Architect's Supplemental Instructions

Architect's ASI No: 033

Webster University

Description: ASI – 033

1 DOMESTIC WATER SUPPLY RISER - LAB WASTE 372B, RESEARCH 374A, TISSUE CULTURE 374B AND COLD ROOM 376

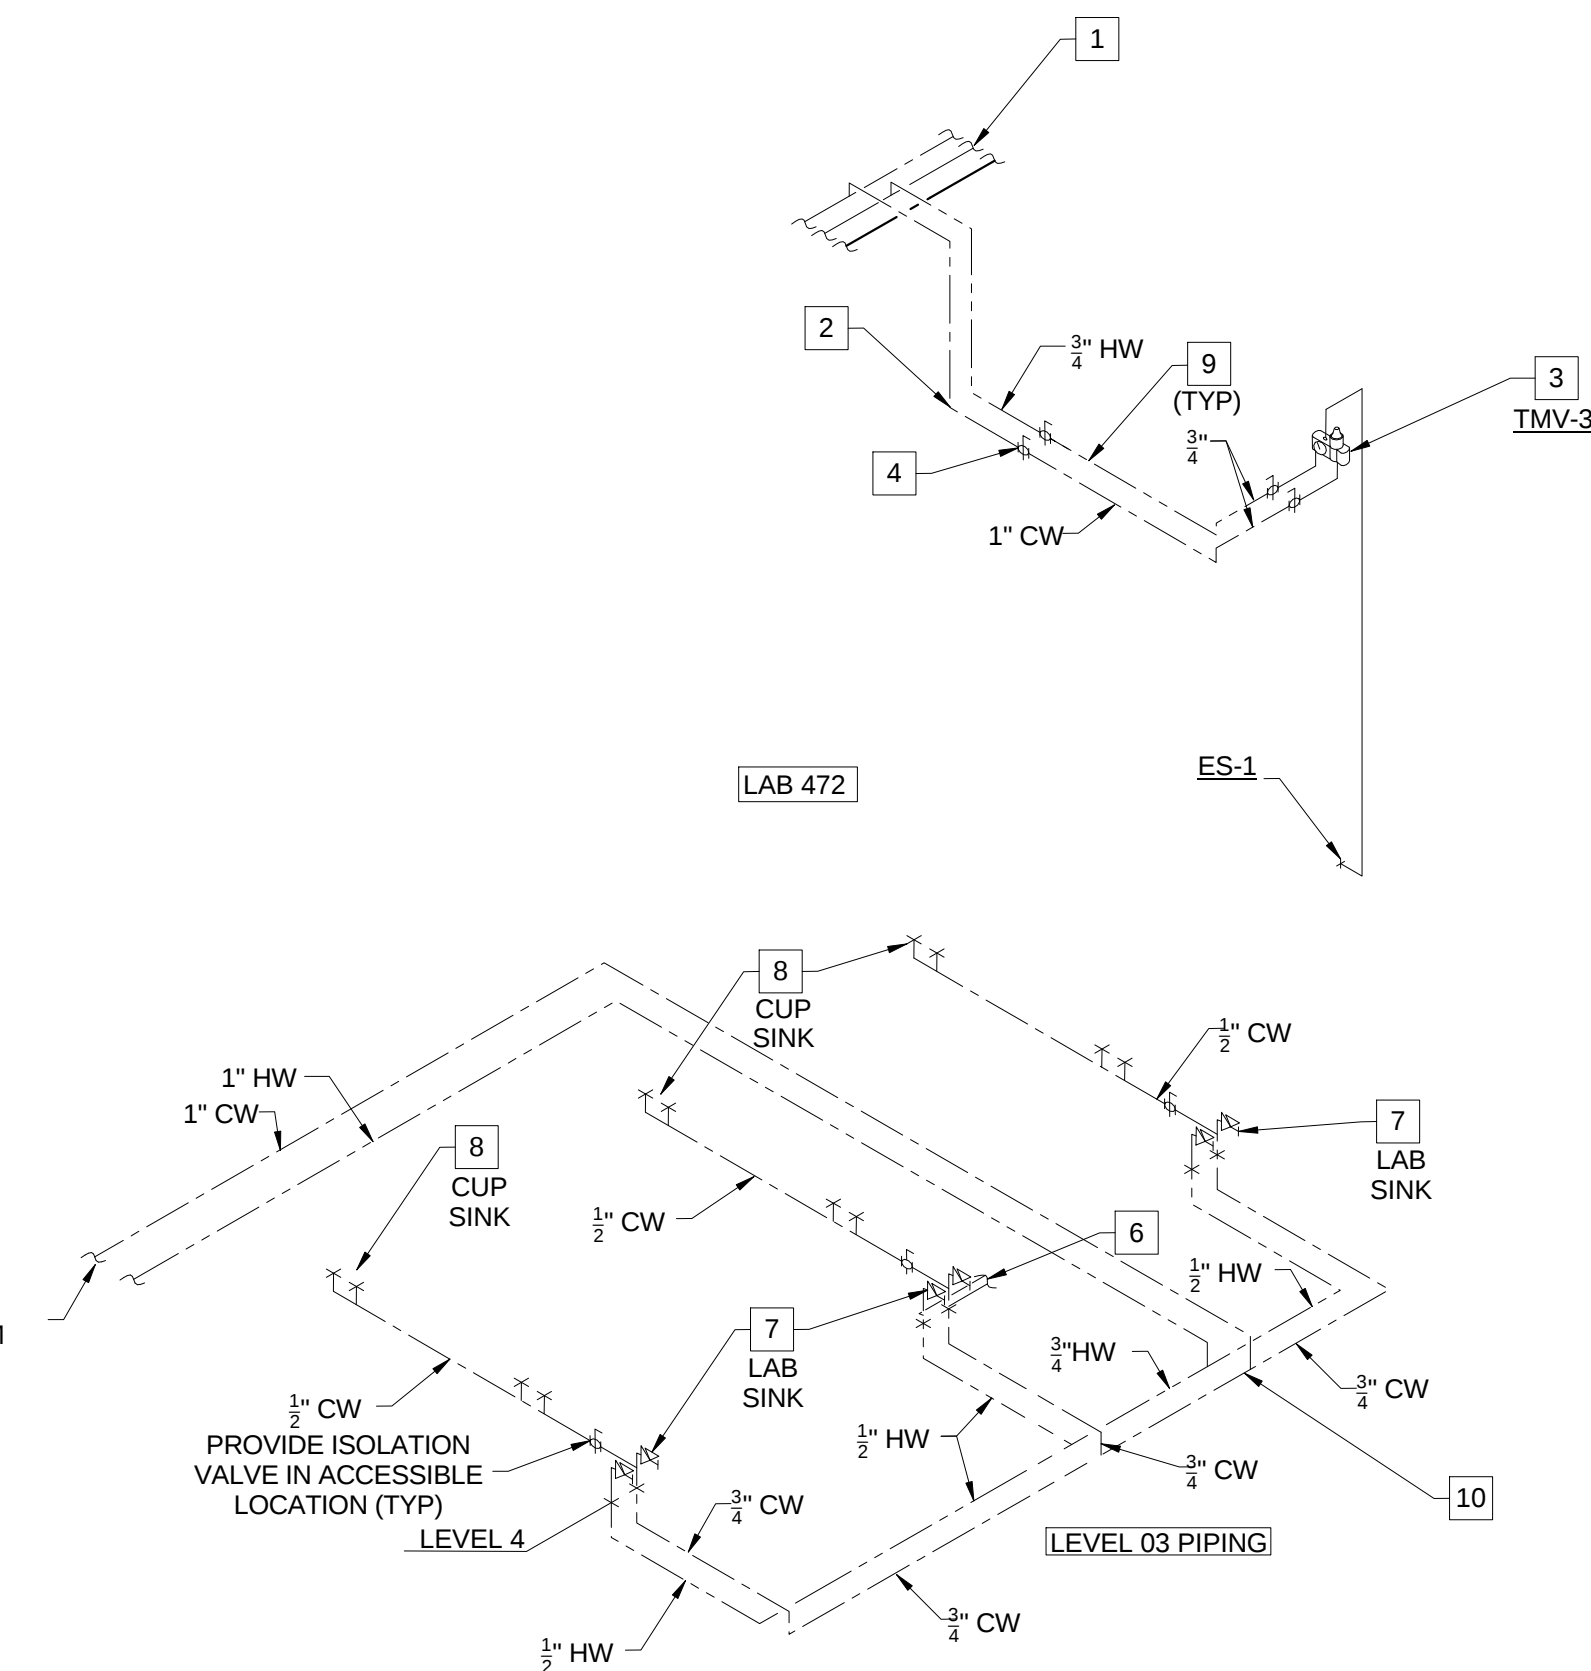
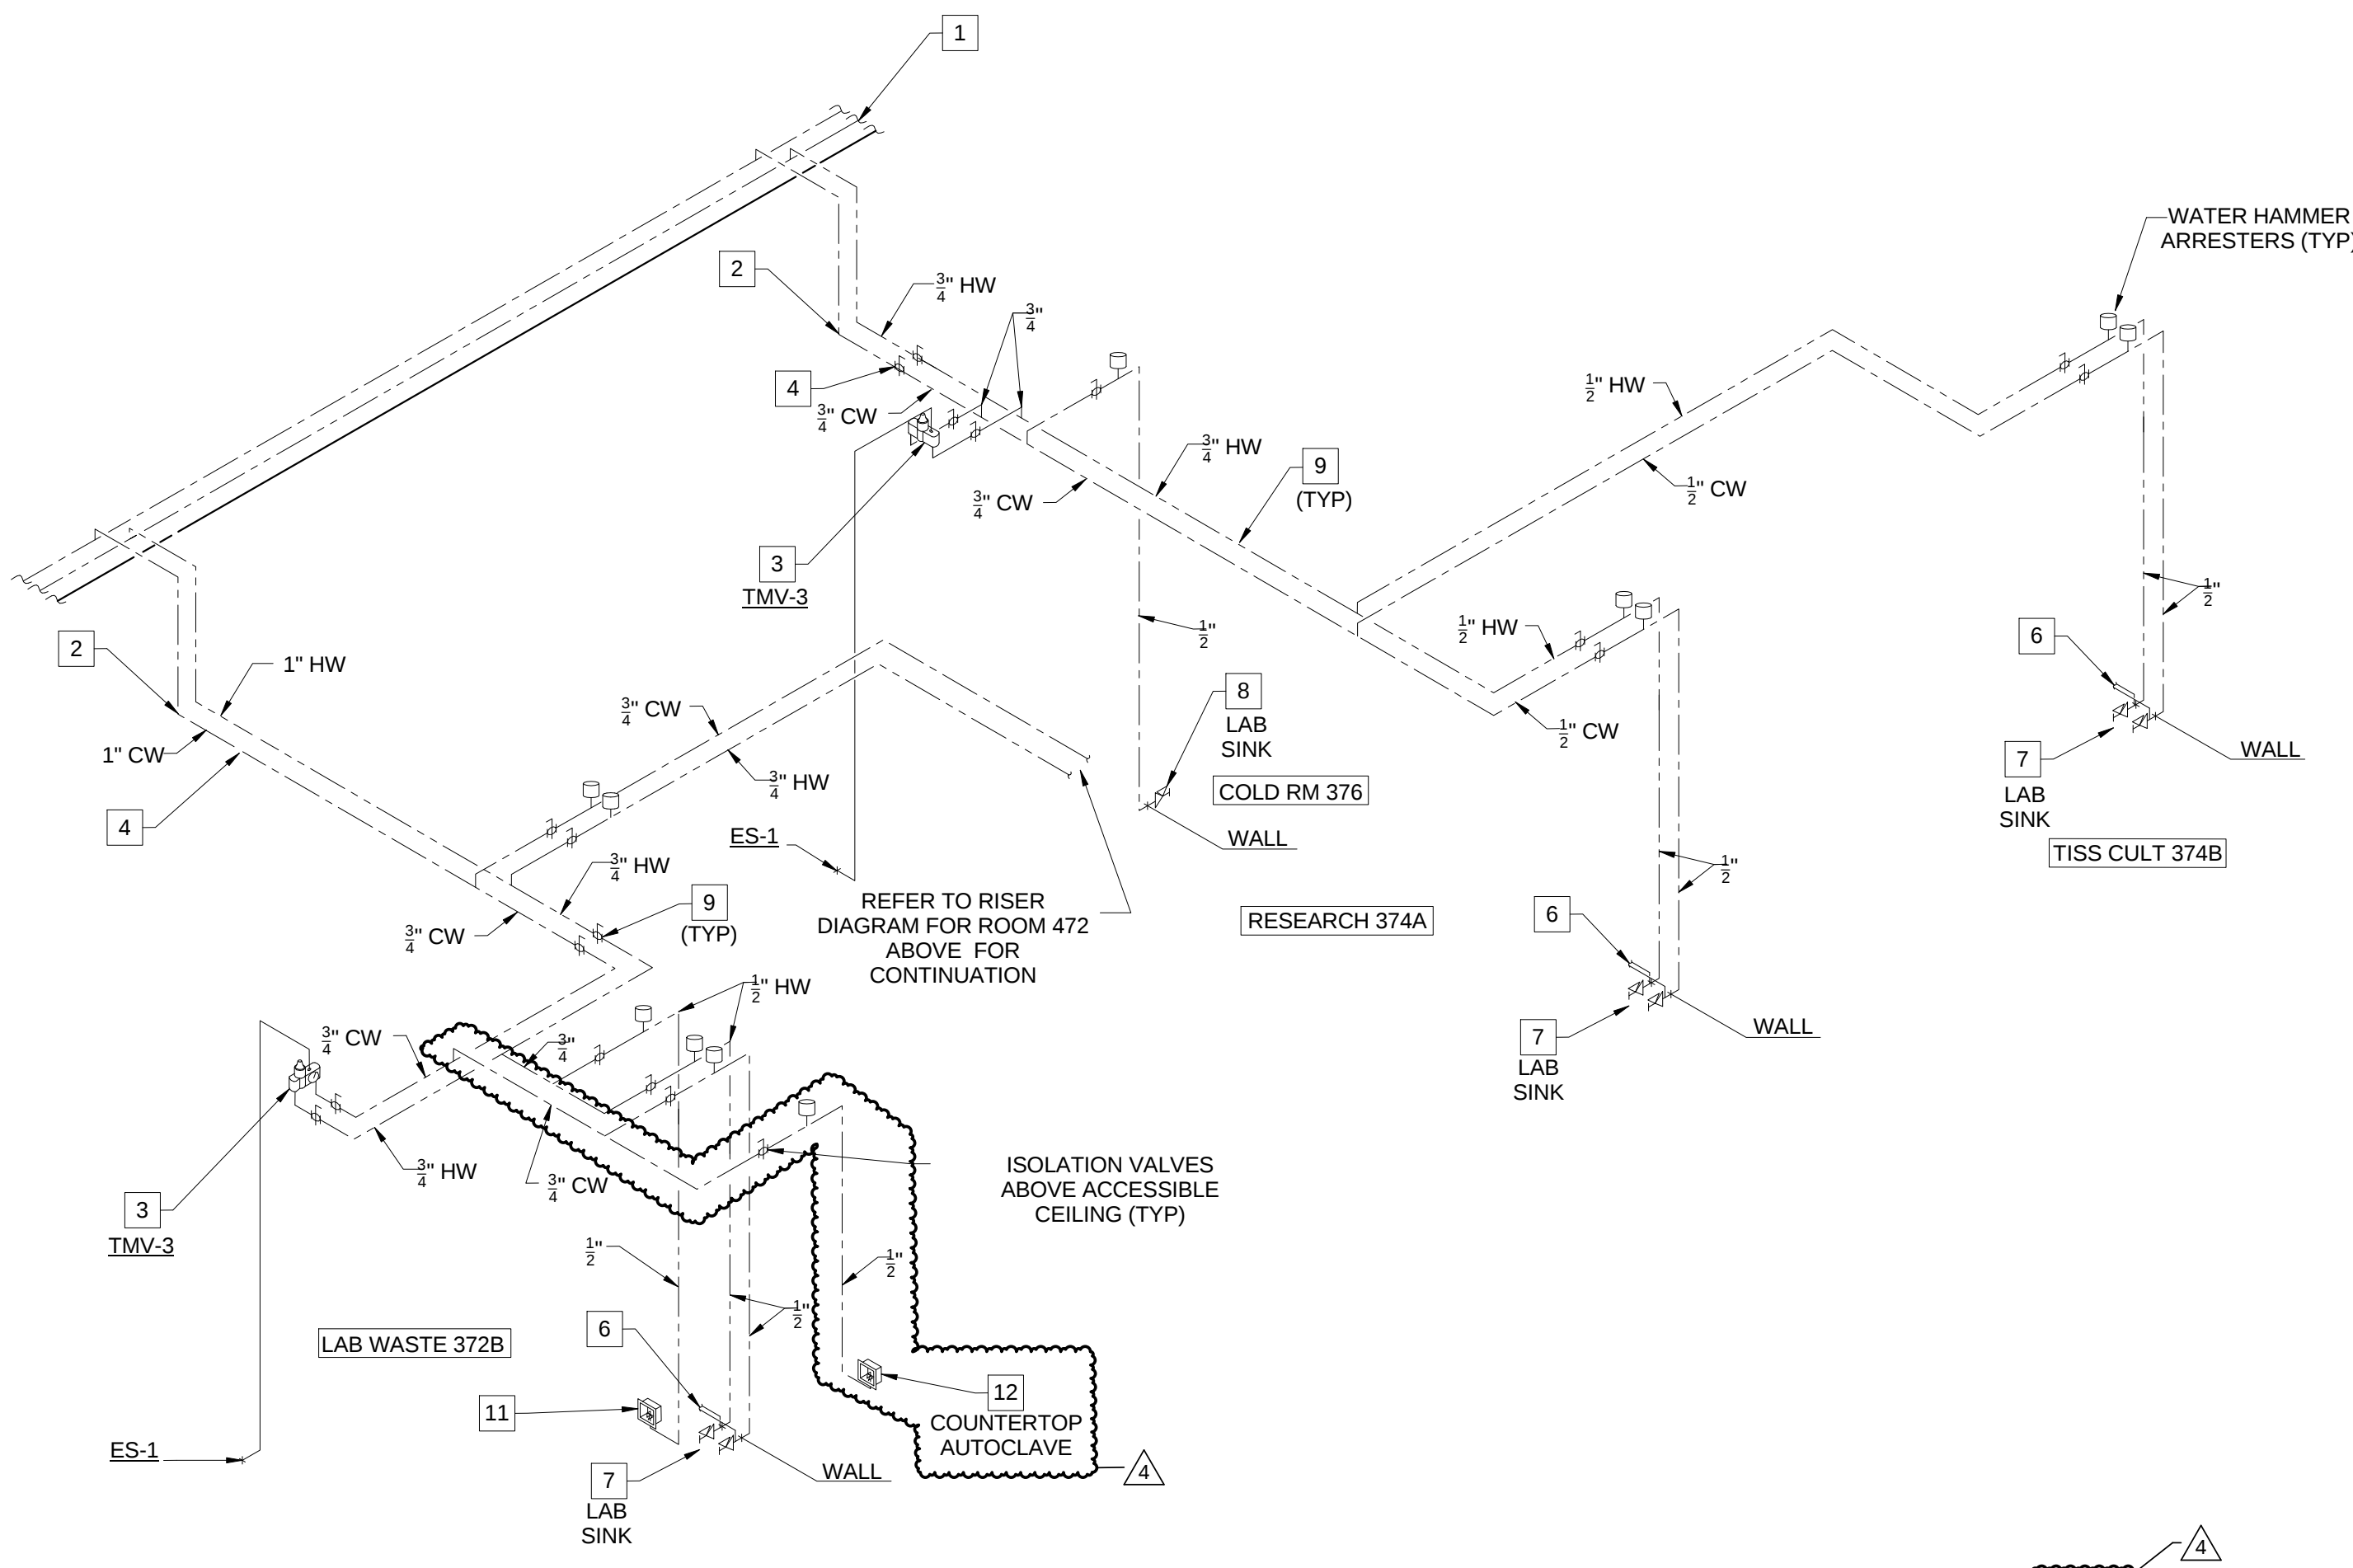
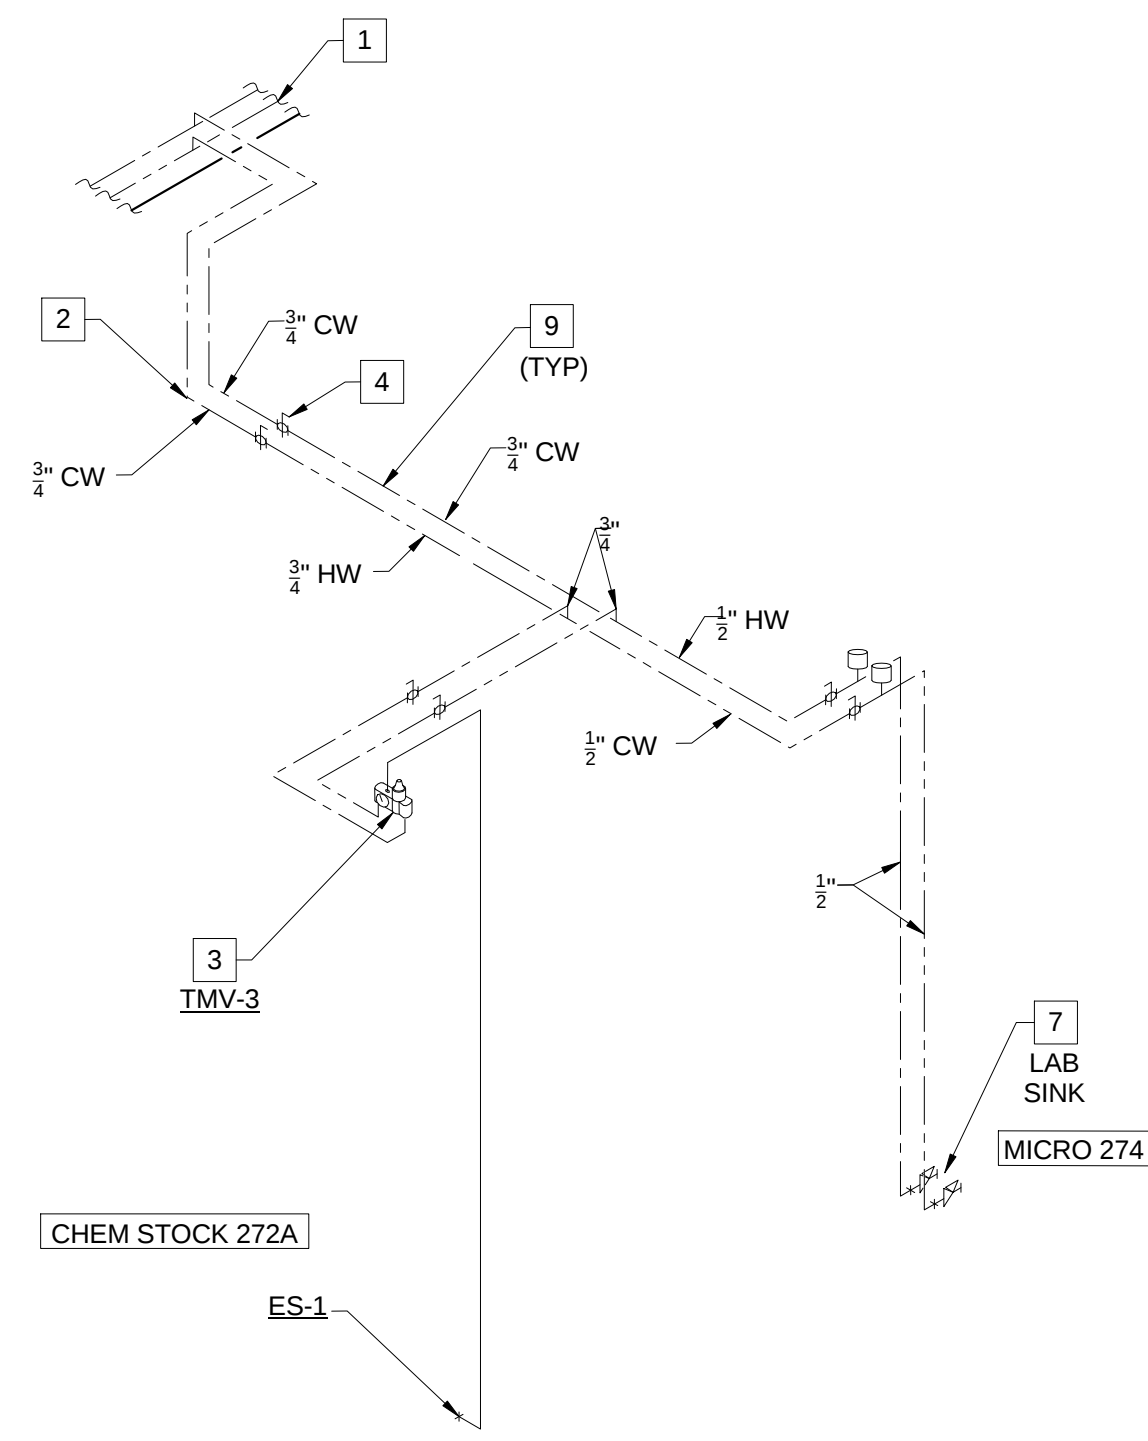
½" cold water to service line down in wall has been provided for the floor mounted Autoclave along with a floor sink for drains. Refer to sheets P0102.A, P0103.A, P0112.A, P0113.A, P0405 and P0408 for changes.
